Addendum No. 2

Project: IU 20250110 - SB000A SITE - CREATION OF STUDENT RECREATION COURTS **Date:** May 12, 2026

From: Magdalena Aravena, PLA

Sheet C3-100 (Revised)

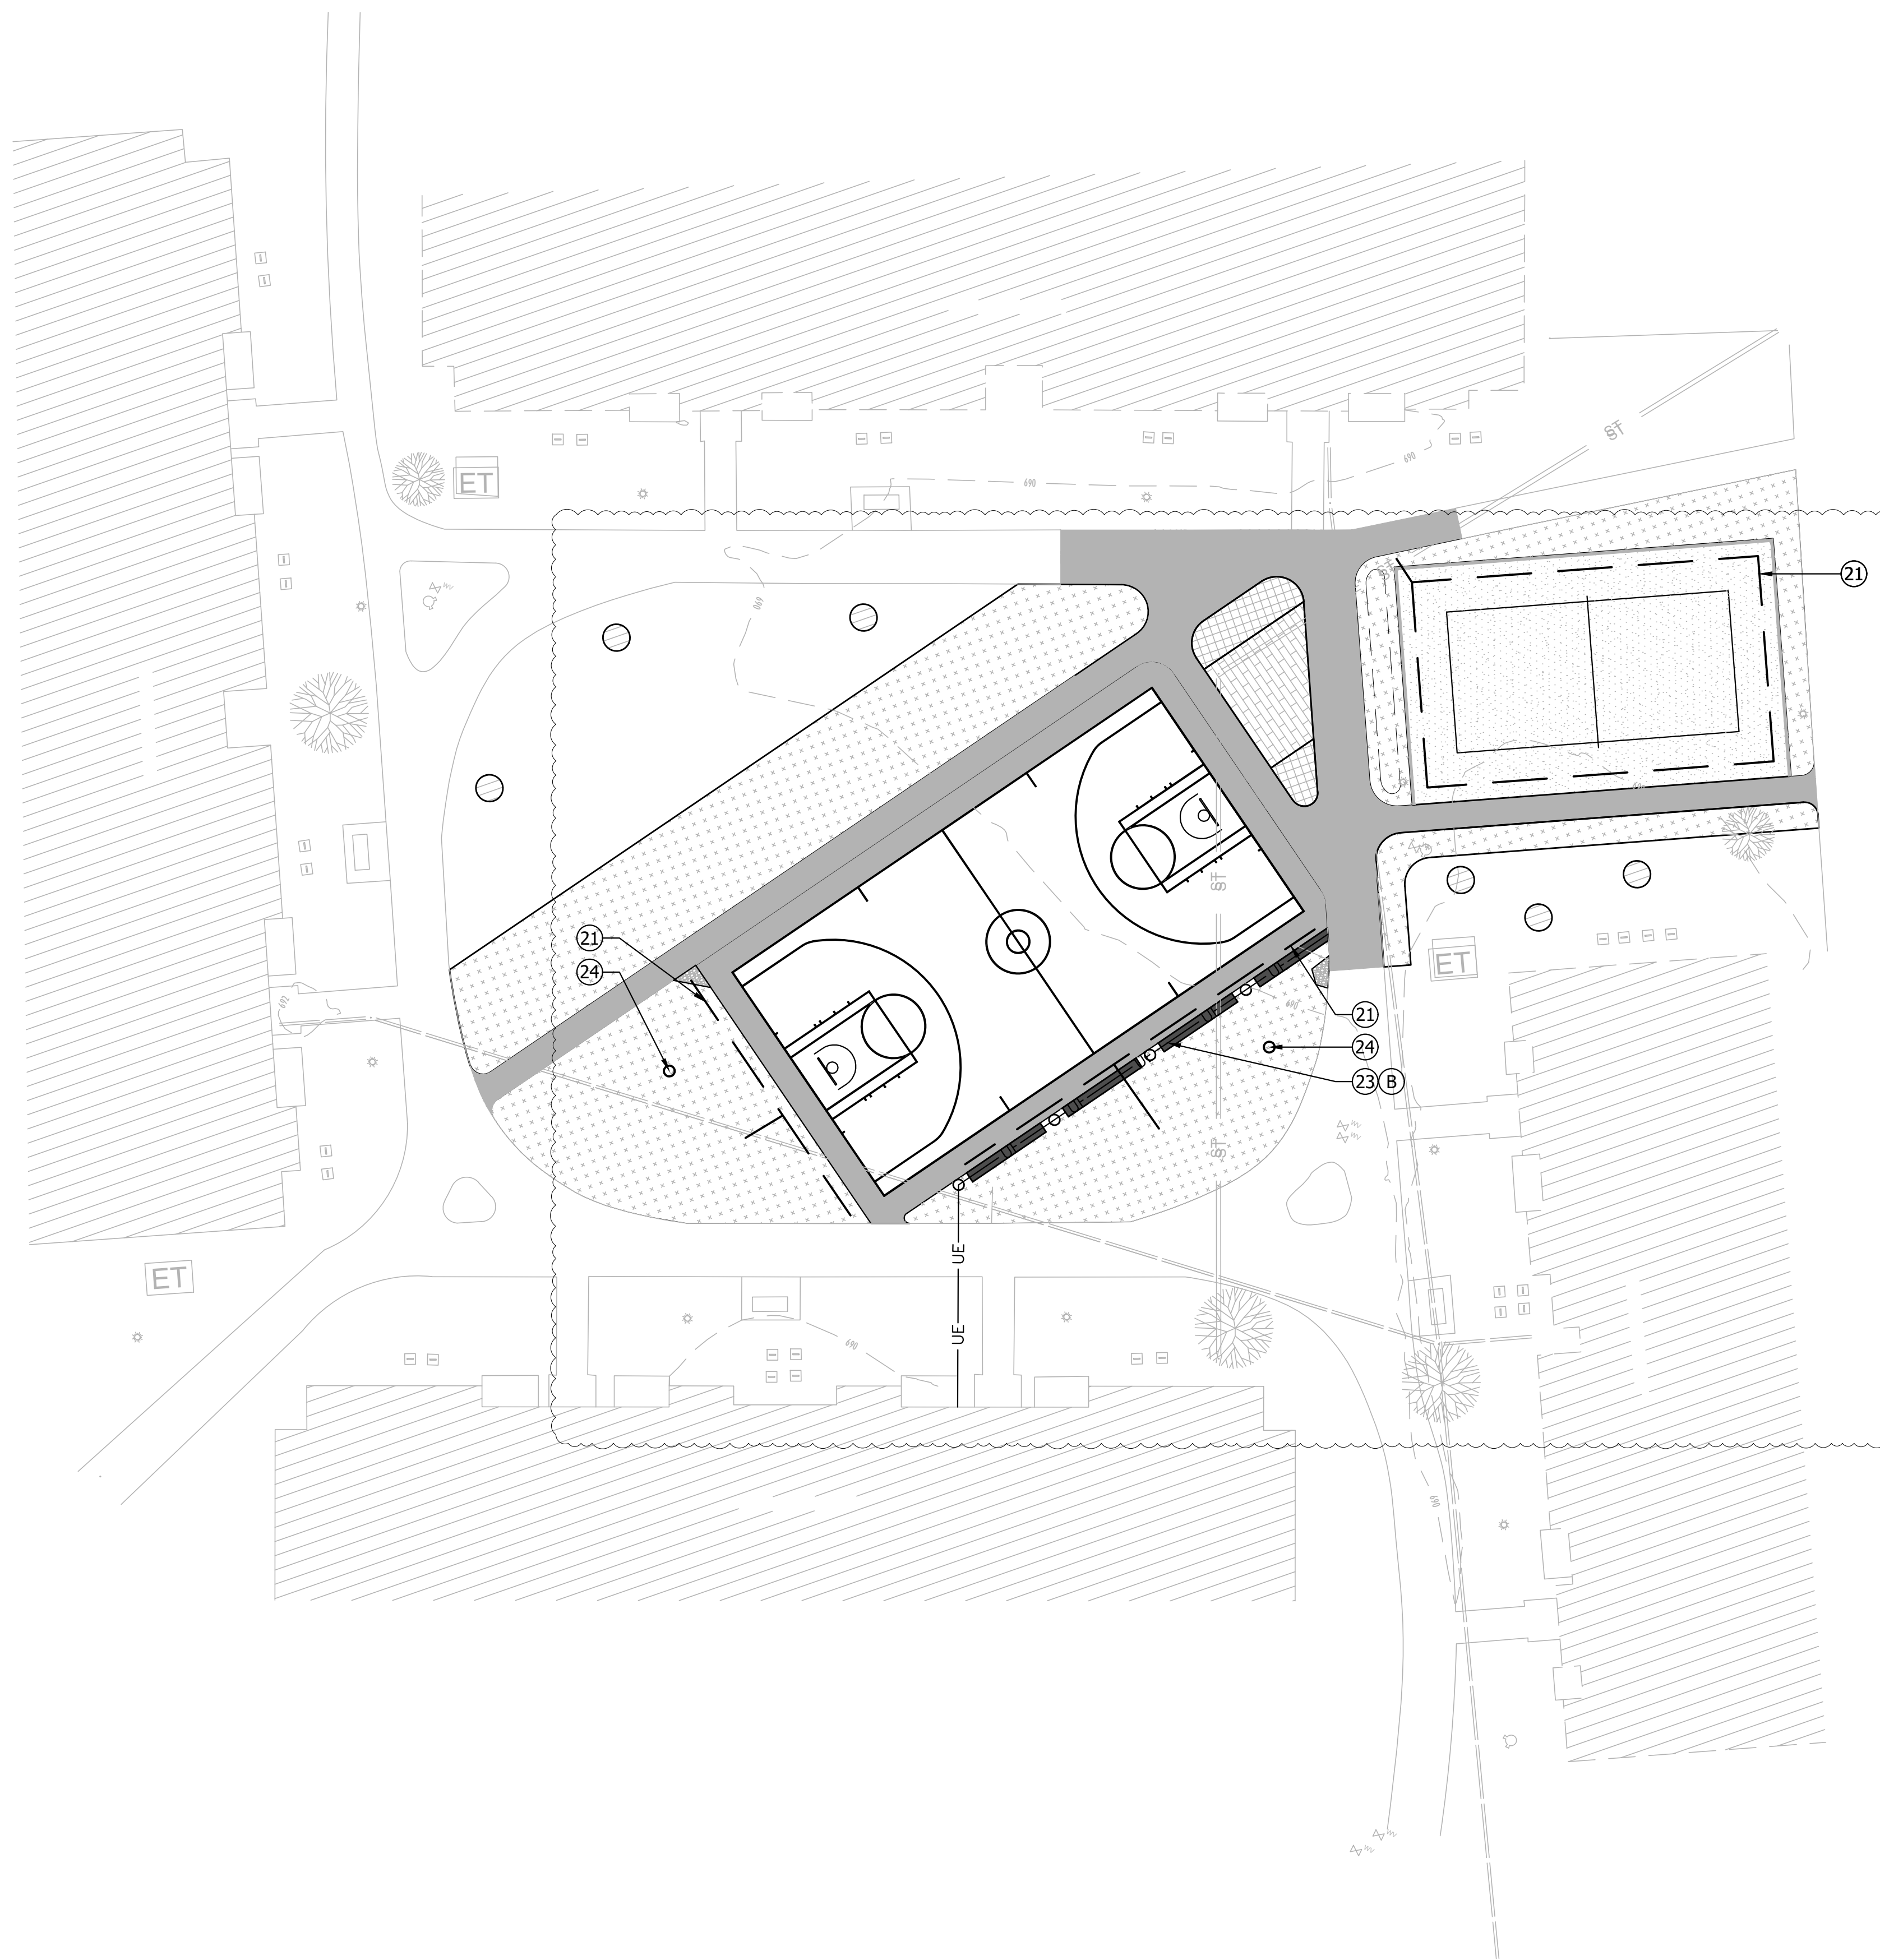
This Sheet has been revised to correct missing keynotes. The diagrammatic placement of underground electrical conduit for Add Alternate 2 has also been added. Note that the connection shall be made at the closest common panel, which is panel HA in room 198 of Whitewater SB885A (building South of the quad). Final location to be coordinated with IU.

12 ASPHALT BASKETBALL SURFACE

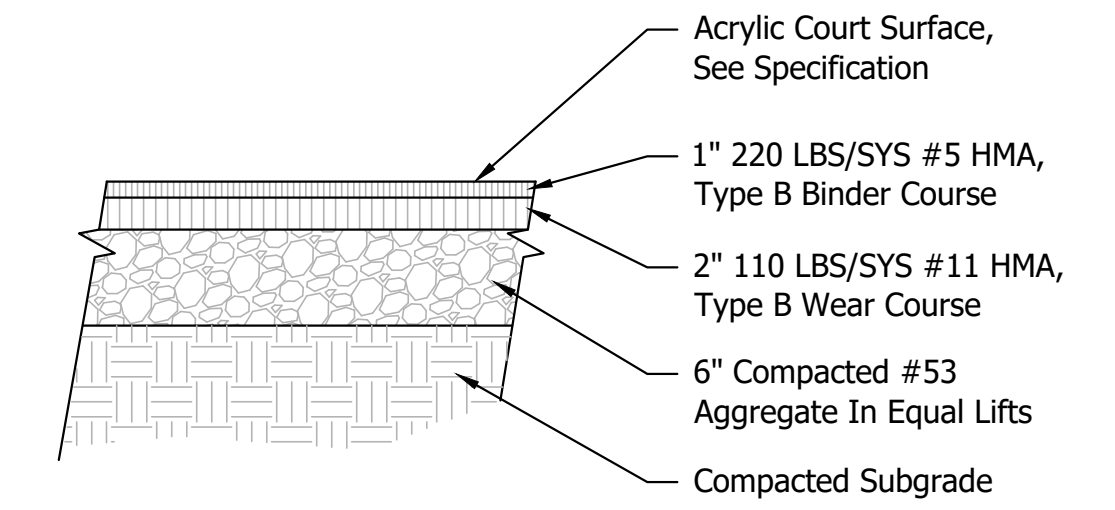
This sheet has been revised to include the Asphalt Basketball Surface detail for Alternate No. 4; and the Concrete Basketball Surface detail has been revised to show acrylic surface on top of the concrete basketball surface to clarify the finish for the base bid concrete basketball surface.

- Q: Can the limits of irrigation where the new irrigation system is to be installed be clearly defined on the plan.
 - A: See answer above.
- Q: Will you be providing a detail on the asphalt surface for the basketball court? I've pulled the specs per the American sports builders association. But it seems like there are a few different thicknesses this surface could be. The stone base should remain as 6" regardless of concrete or asphalt?

- A: See Detail Sheet revised as attached to this addendum. Stone base shall be 6" regardless if concrete or asphalt as shown in the details.
- Q: Will the basketball court follow the rebar installation detail for sidewalks?

4 CONCRETE BASKETBALL SURFACE

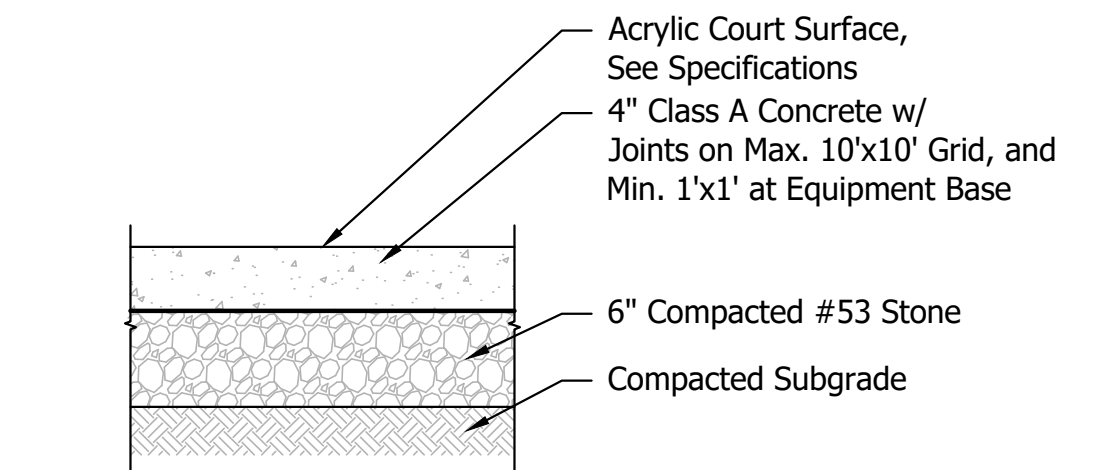
- Q: Is there a final surface finish desired on the concrete for the basketball court? Should this concrete be sealed? This concrete should be the same IU beige color as the sidewalks?

- A: See Concrete Basketball Surface detail.
- Q: Would fiber in concrete mix be allowable in lieu of rebar for the sidewalks and basketball court?
 - A: That is not an acceptable substitution. All concrete sidewalks shall follow the sidewalk detail shown as this is required per IU standards.

- A: The base bid surface finish for the concrete court pavement shall be an acrylic court surface, to be installed per manufacturer specifications.
- Q: Detail for sidewalk reinforcement is 24" OC where spec states 30" OC. Confirm which spacing is correct.
